## ADDENDUM No. 2

ITB No. 4564

### GEDDES DAM – GATE RECOATING AND REPAIRS

DWG. NO. 520 M 220

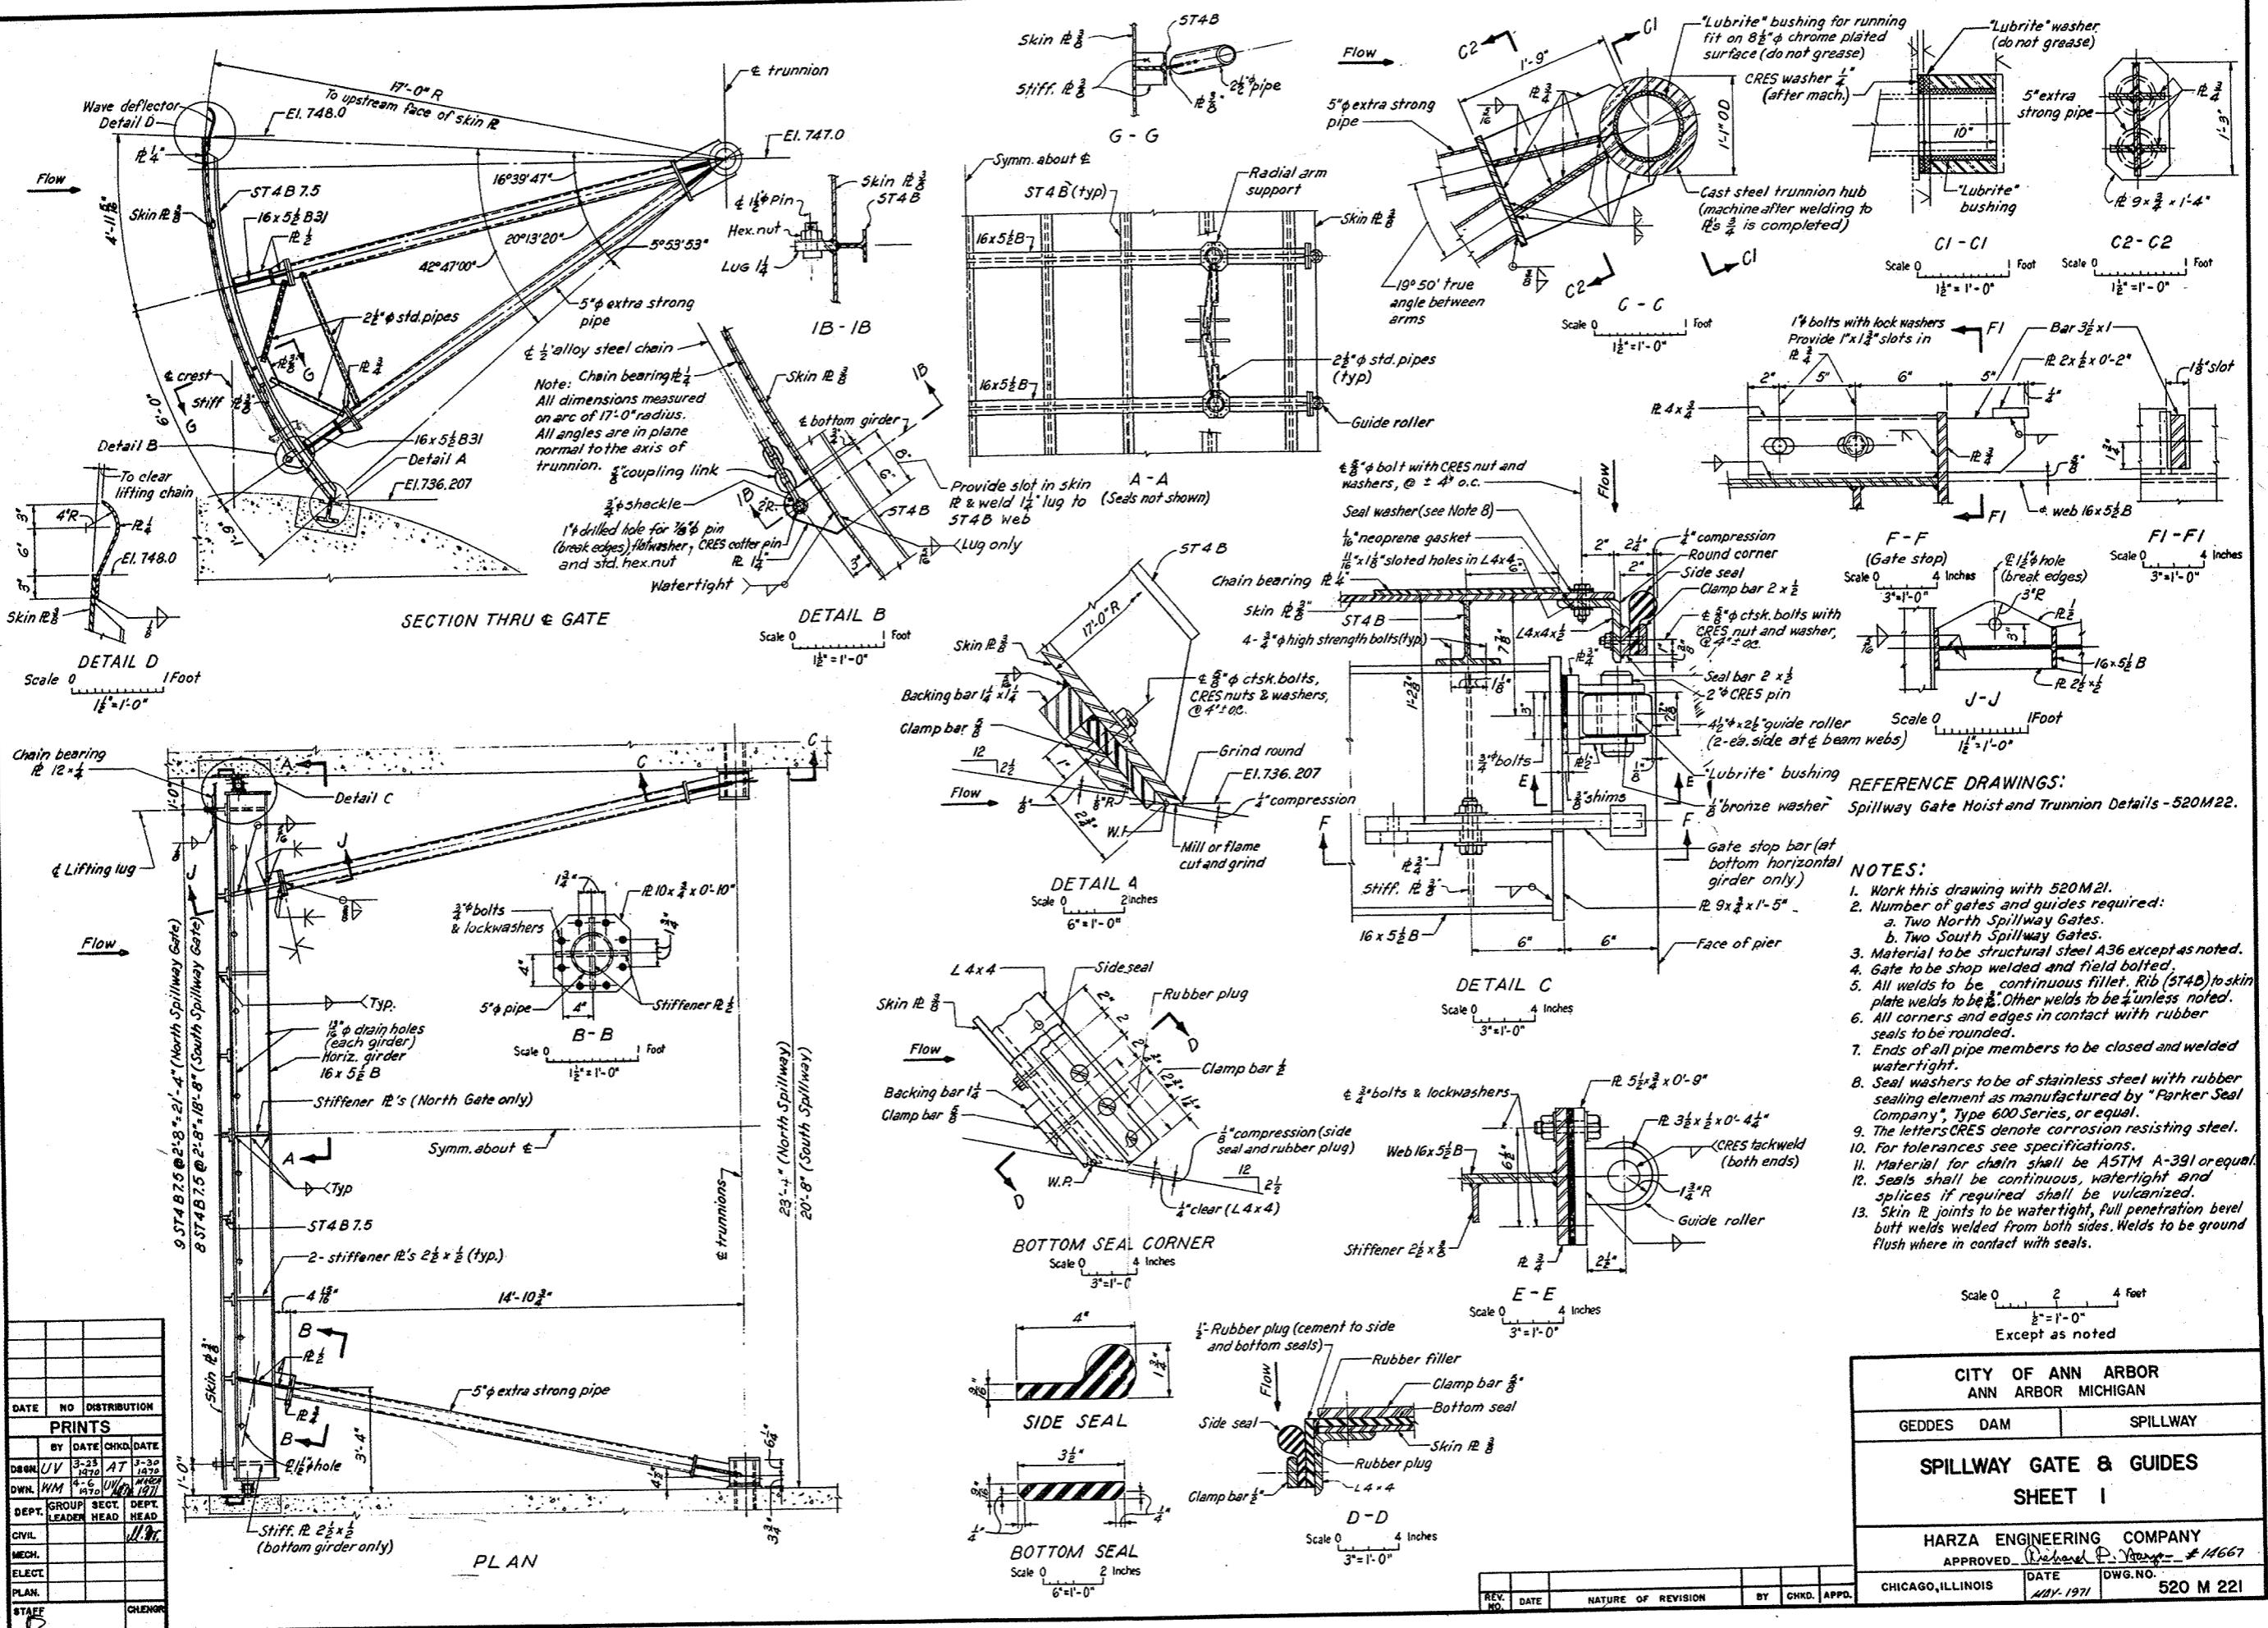
**Add:**  
*Temporarily remove ½" bubbler lines at each stoplog rail (2 per bay) and reinstall after stoplogs are removed. Note: There are two (2) different sets of stoplogs to transport to and from the site – Bay 1 and Bay 2 are different from the stoplogs for Bay 3.*

**Add attached reference drawings (4 pages): 1971 Harza, 520 M 220; ...221; ...222; ...223, showing original gate and stoplog design.**

HARZA ENGINEERING COMPANY  
 APPROVED: [Signature] #14667  
 DATE: MAY 1957  
 DWG. NO.: 520 M 221

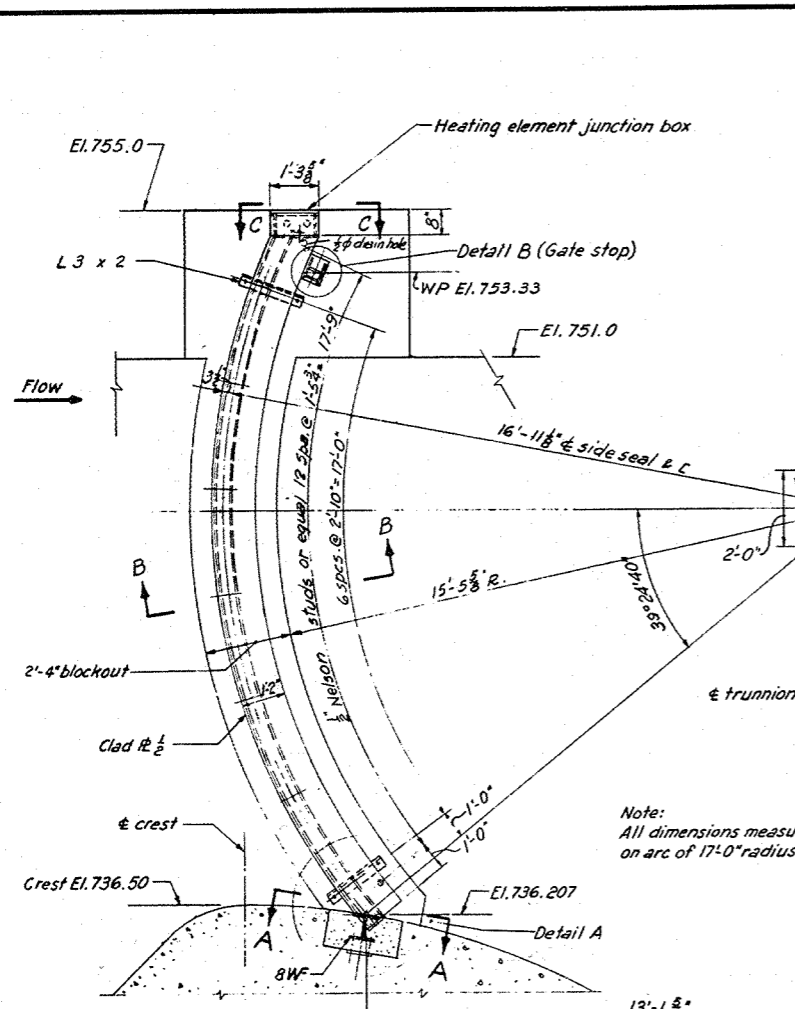
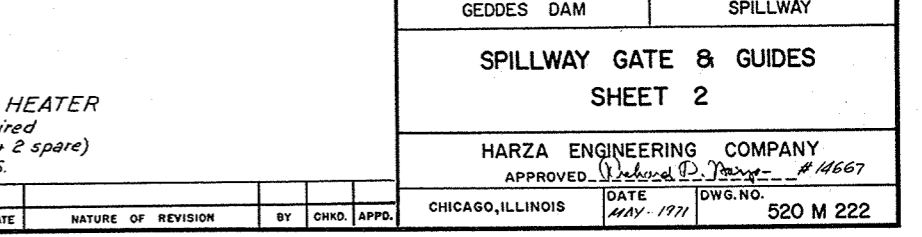
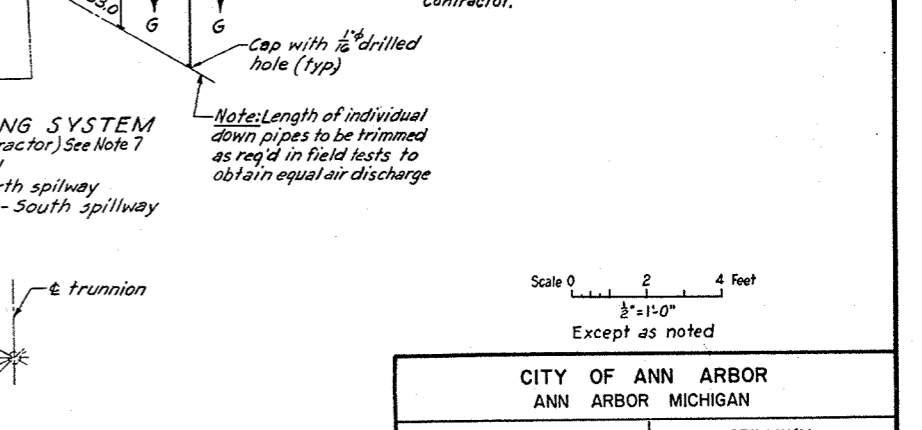
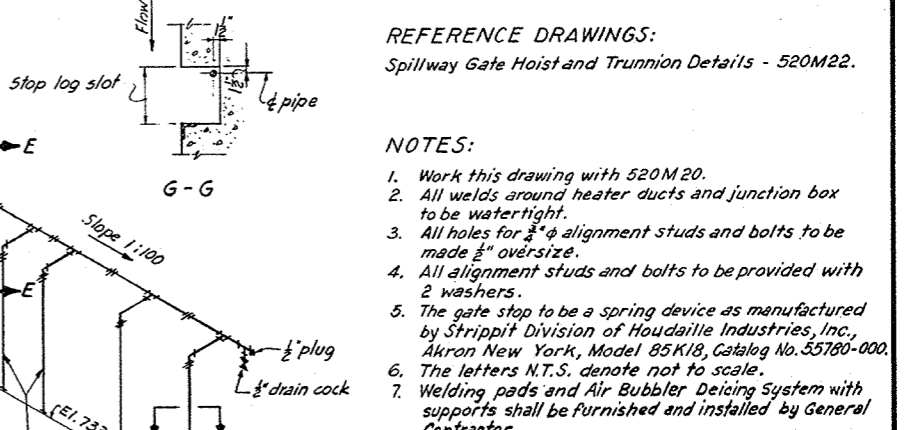
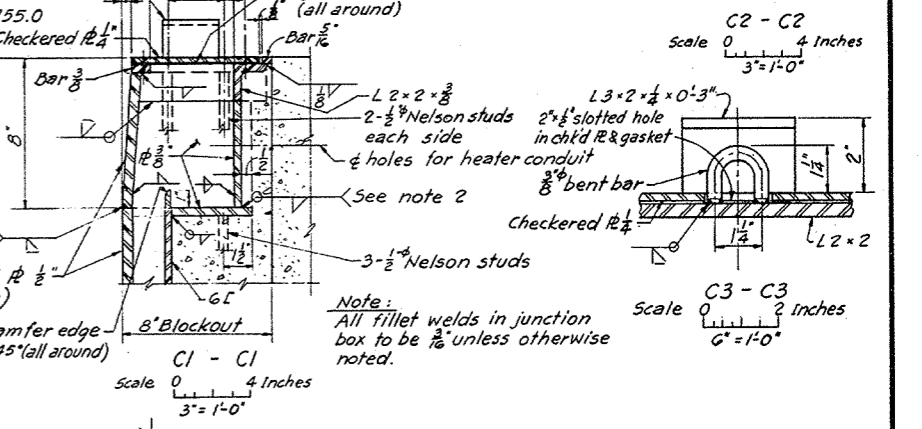
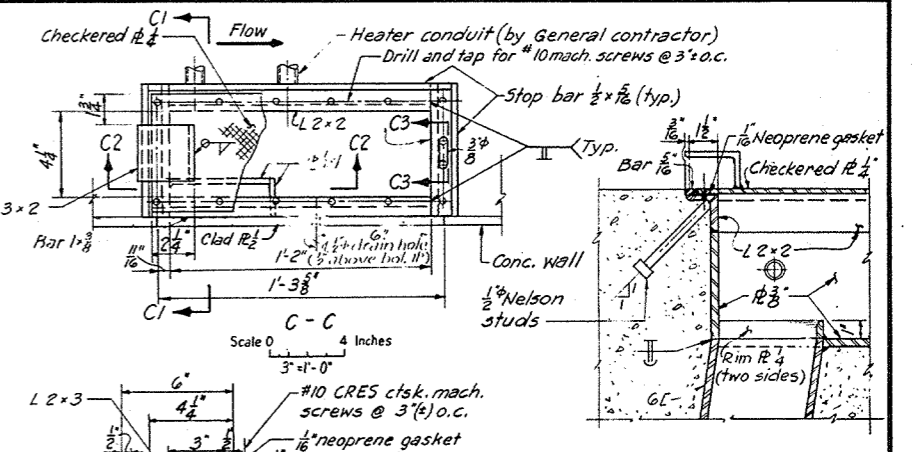
**Add:**  
*Recoating of gates shall include recoating of embedded gate stops in each bay (2 per bay). Position and type of stops in Bays 1, 2 and 3 is similar to Bay 4 - see Details 4, 5 and 6 on S-502. Remove spring device before recoating and re-install after coating is complete.*
